# HARNETT CENTRAL PRESS BOX

HARNETT CENTRAL PRESS BOX  
HARNETT COUNTY SCHOOLS  
2911 HARNETT CENTRAL RD, ANGIER, NC 27501

PROJECT INFORMATION:  
DATE: 1/10/2023  
DRAWN BY: RDH  
CHECKED BY: JEL  
SHEET TITLE  
COVER SHEET  
SHEET NUMBER  
G-001  
PROJECT# 21-11110

SHEET NUMBER: E-301

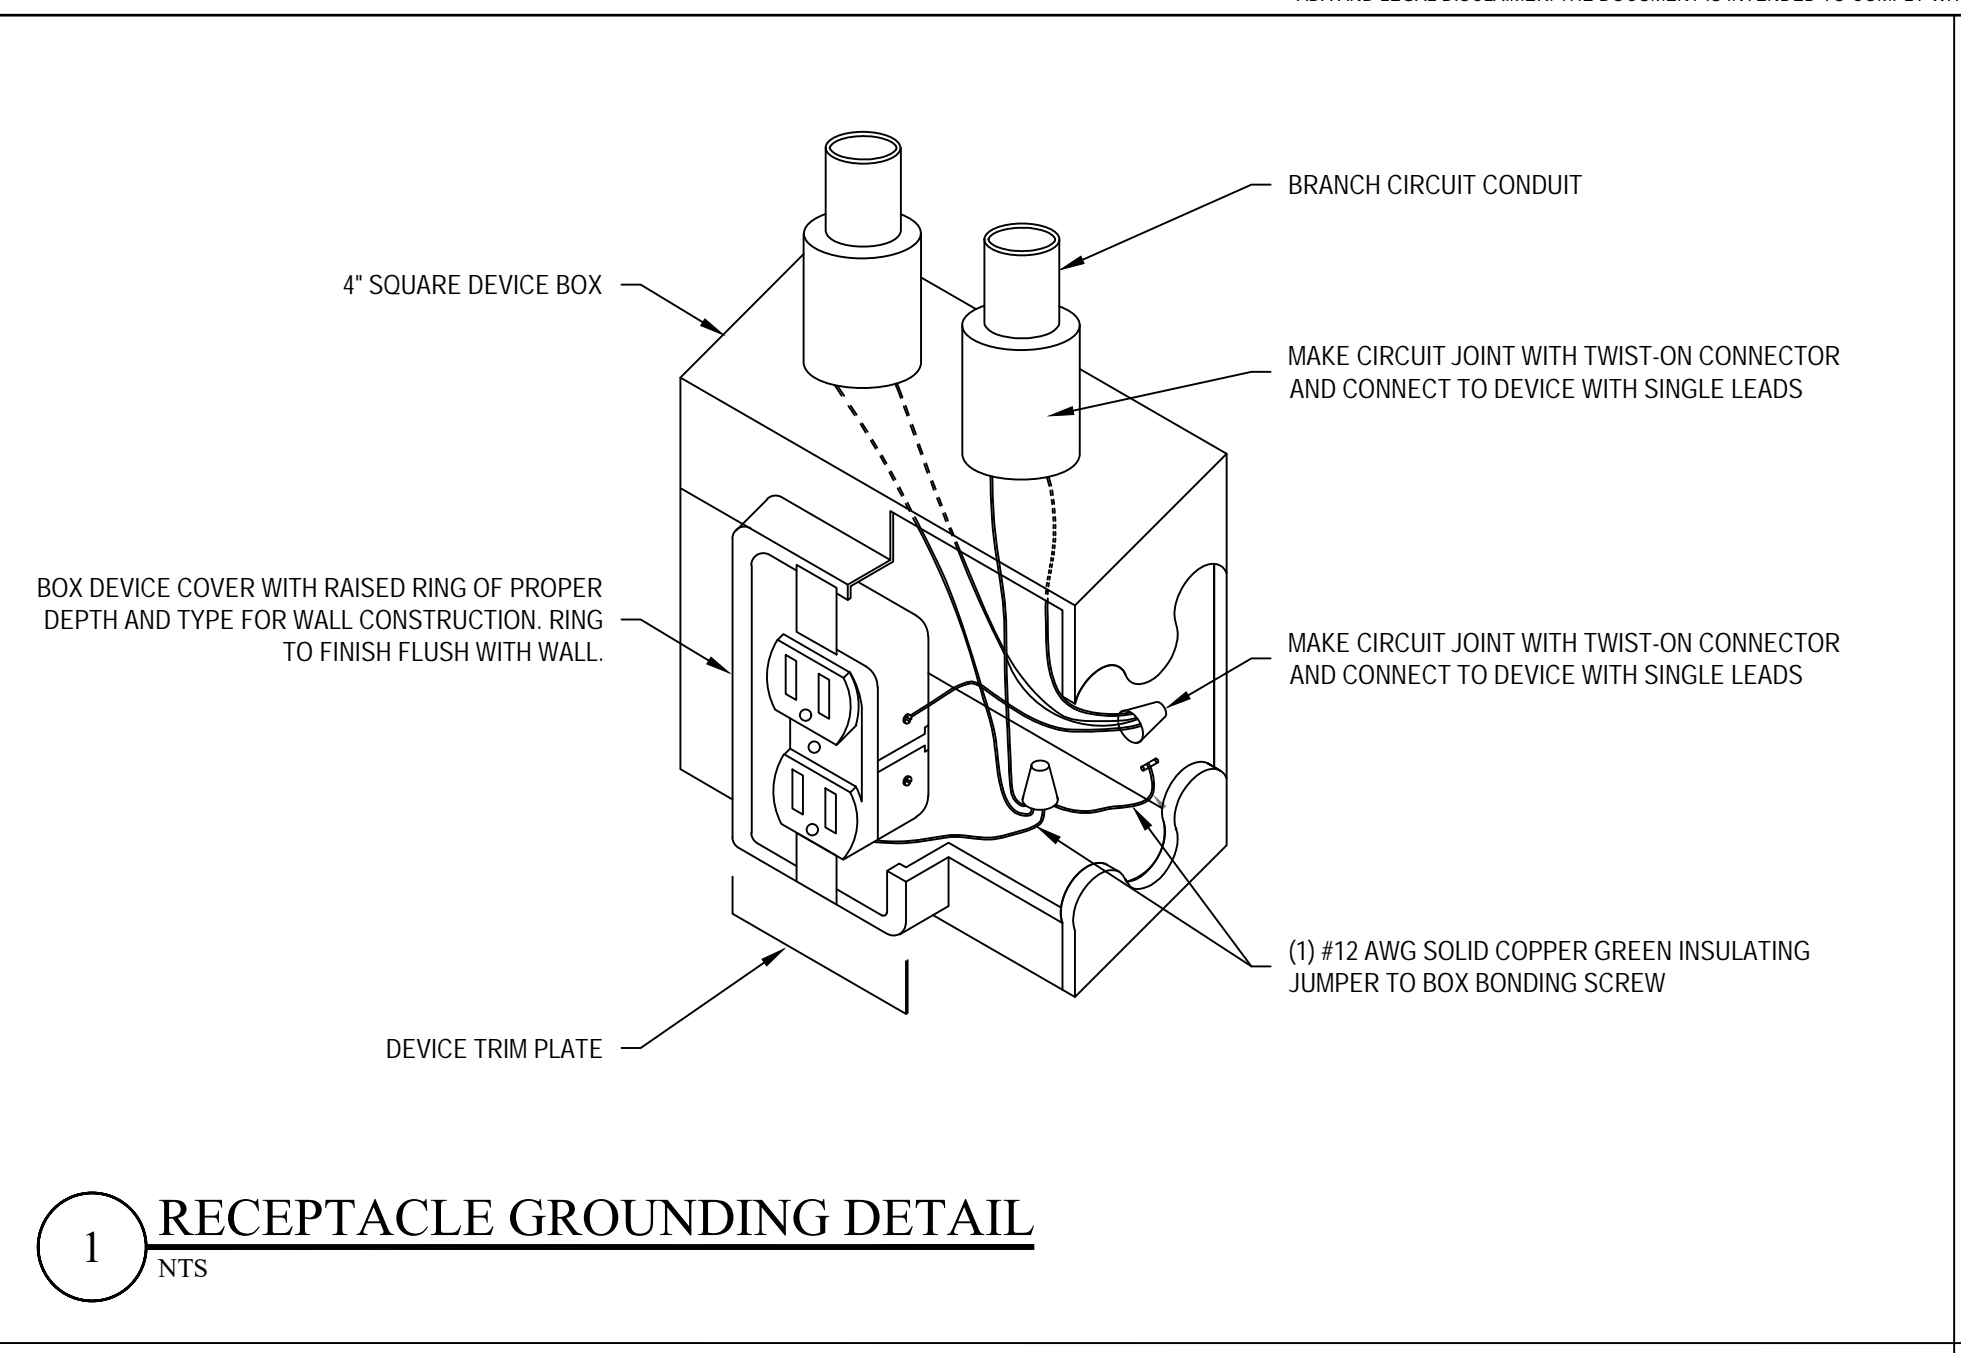
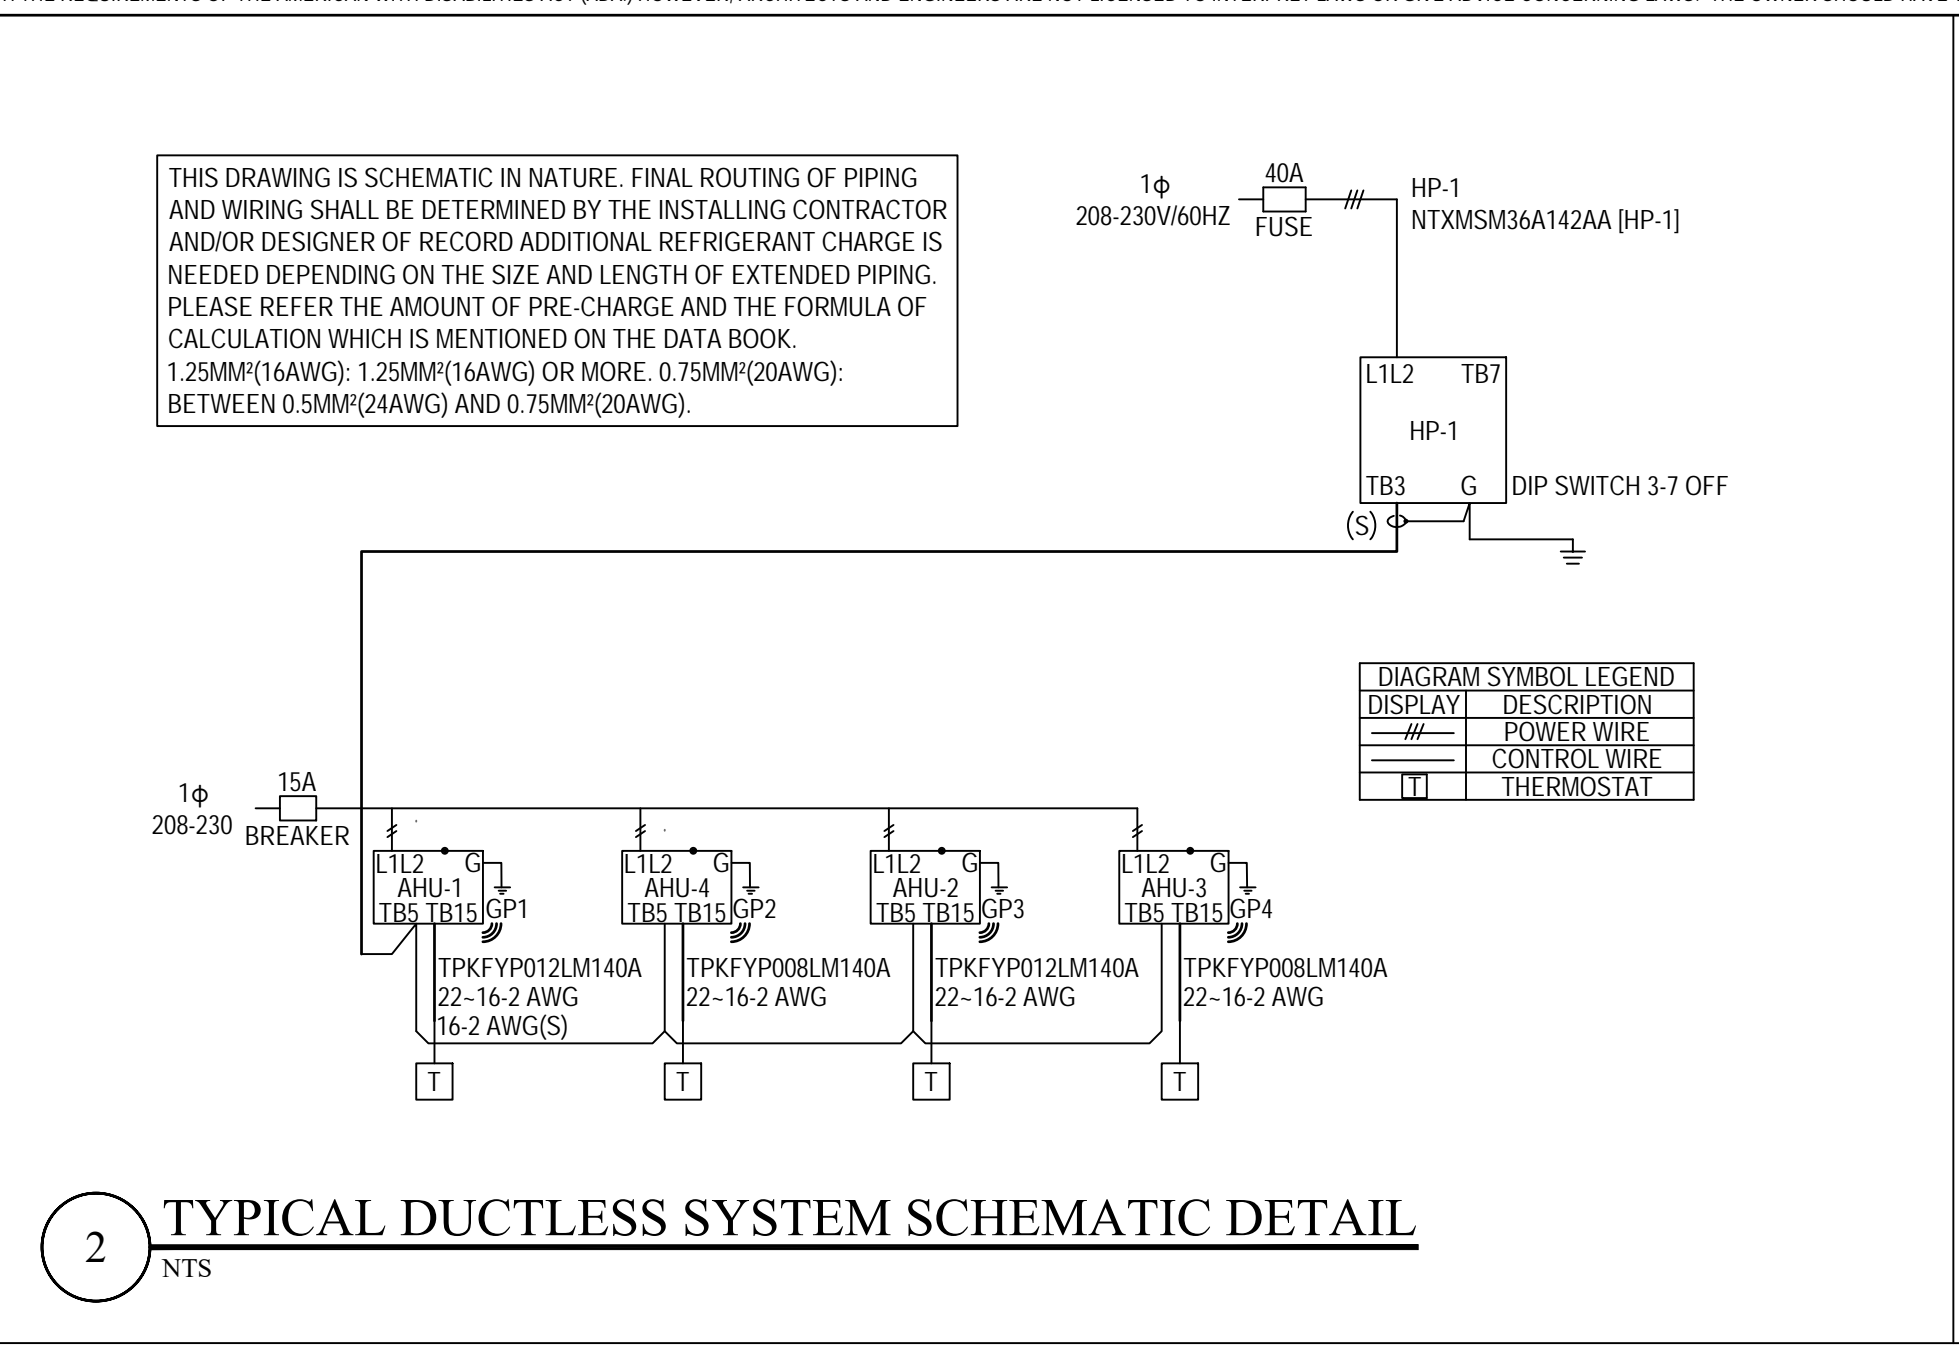
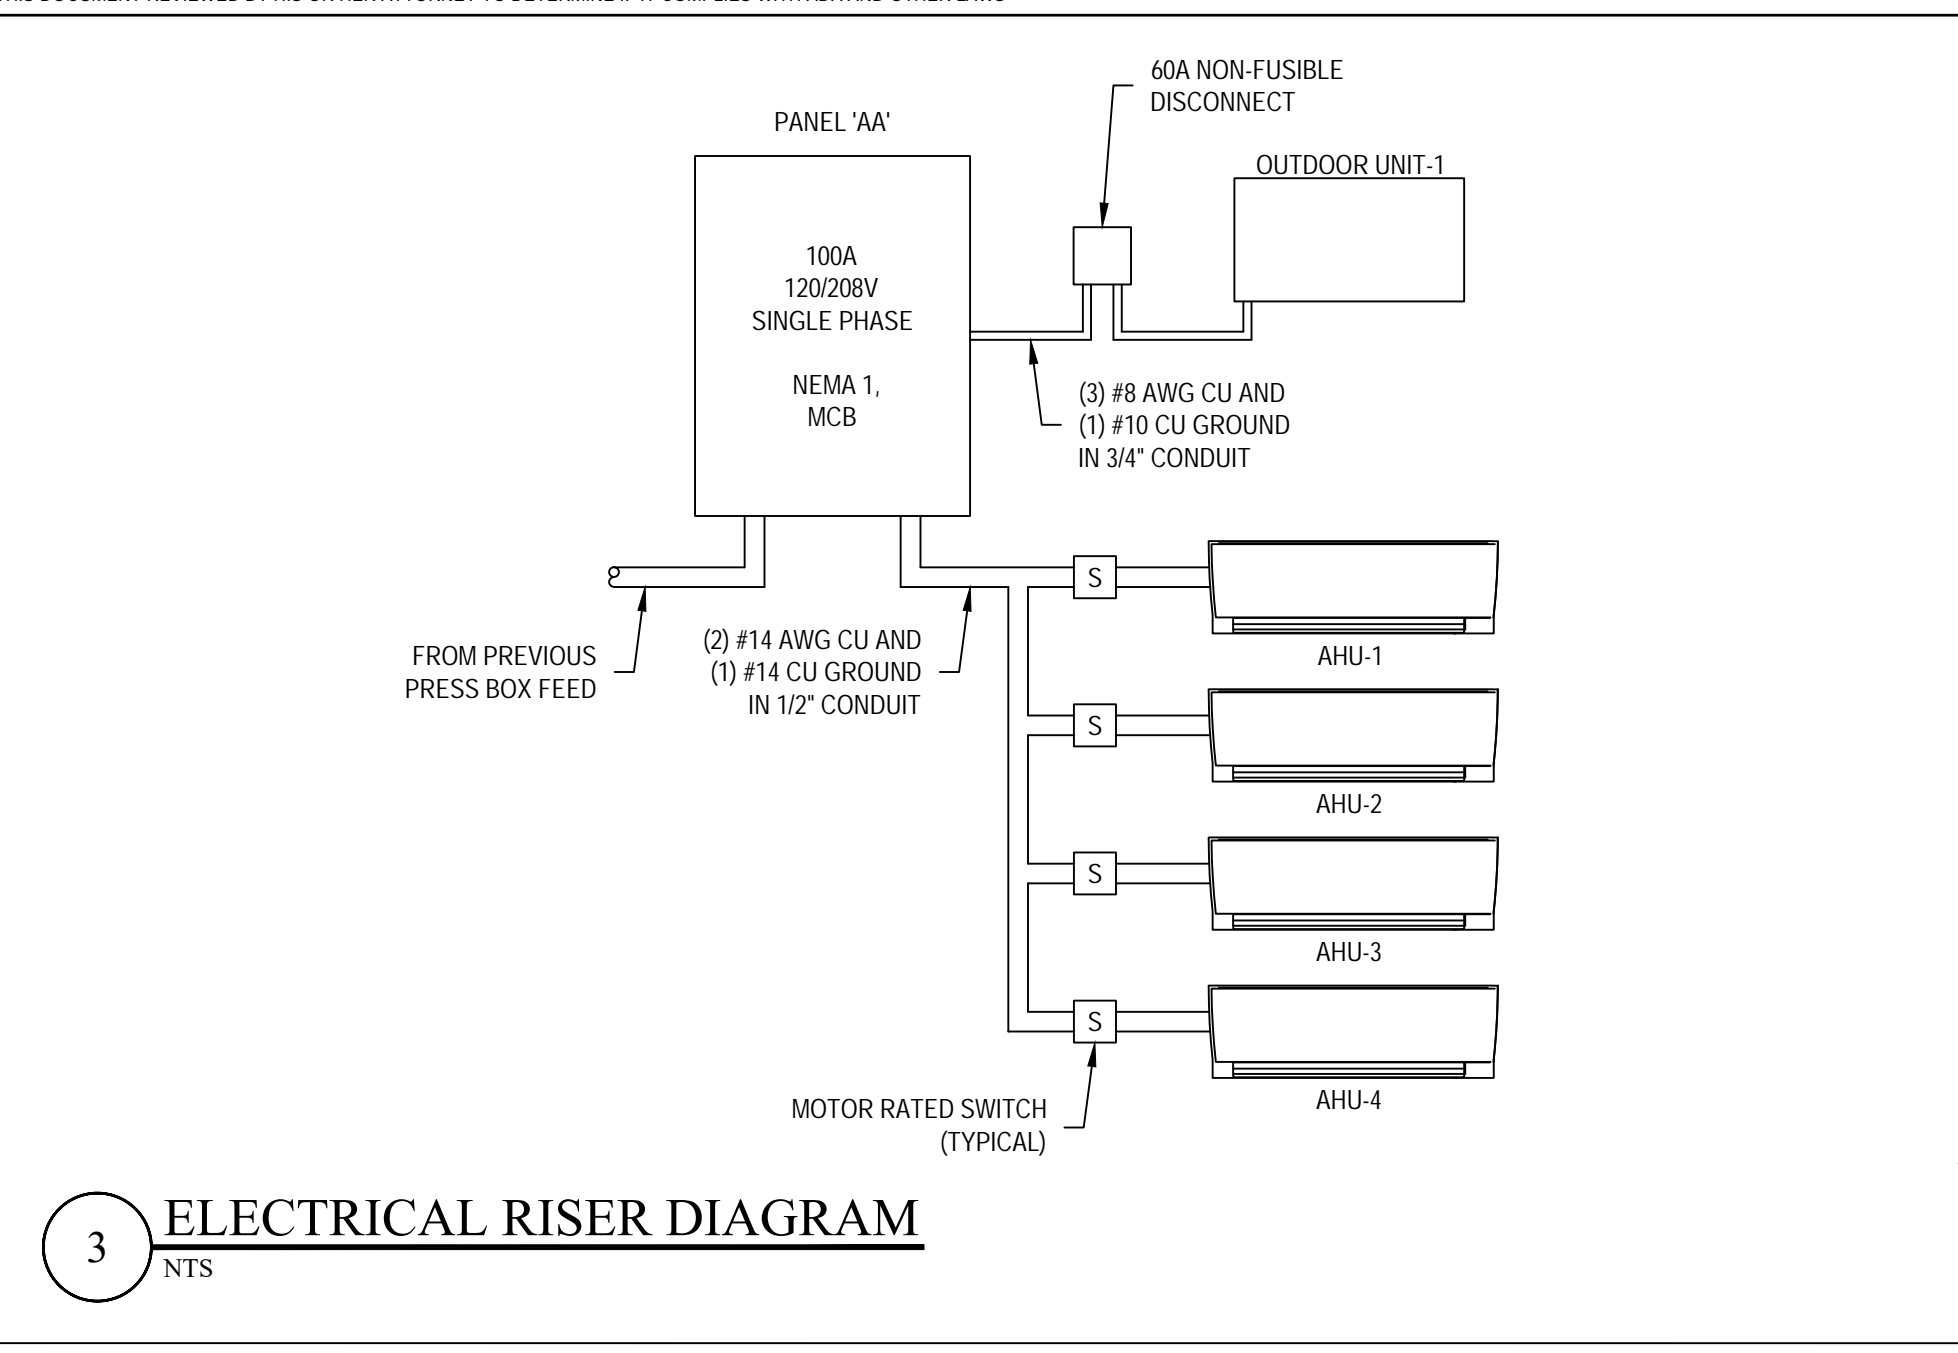
REV#	DATE	DESCRIPTION
1	4/12/2023	PANEL SCHEDULE UPDATED
2		
3		
4		
5
